Kentucky Trailer
Attr: Recall-22KTB01
3400 Robards Court
Louisville, KY 40218
(502) 410-6019
Recall-22KTB01@kytrailer.com

IMPORTANT SAFETY RECALL
NHTSA Safety Recall No. 22V419

What is the Defect?

REAR WALK BOARD RACK HANGER

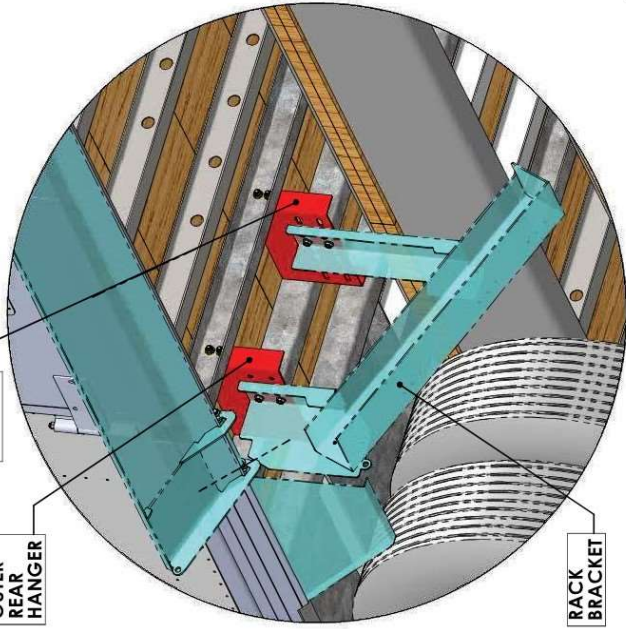
REMOVE AND REPLACE THE FASTENERS CONNECTING THE HANGERS TO THE CROSSMEMBERS AS WELL AS THE FASTENERS CONNECTING THE RACK BRACKETS TO THE HANGERS.

- (4) FASTENERS IN OUTER REAR HANGER
- (4) FASTENERS IN INNER REAR HANGER
- (8) FASTENERS IN RACK BRACKET, (4) PER VERTICAL

KT# 1151438100
3/8"-16 X 1" HEX HEAD BOLT,
GRADE 8, YELLOW ZINC

KT# 1530438001
3/8" FLAT WASHER, GRADE 8, YELLOW ZINC

KT# 1421438006
3/8"-16 FLANGED STOVER-TYPE LOCKNUT, GRADE 8,
YELLOW ZINC, WAXED

- NOTES:
1. WASHER TO BE INSTALLED UNDER BOLT HEAD
 2. TORQUE BOLT HEAD OR NUT TO 37-42 FT/LBS.

FRONT WALK BOARD RACK HANGER

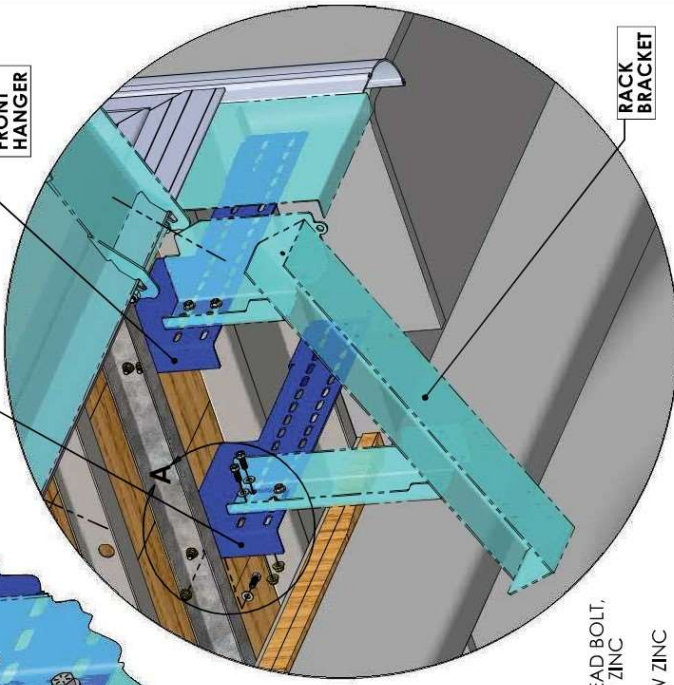
- (2) FASTENERS IN OUTER FRONT HANGER
- (2) FASTENERS IN INNER FRONT HANGER
- (8) FASTENERS IN RACK BRACKET, (4) PER VERTICAL
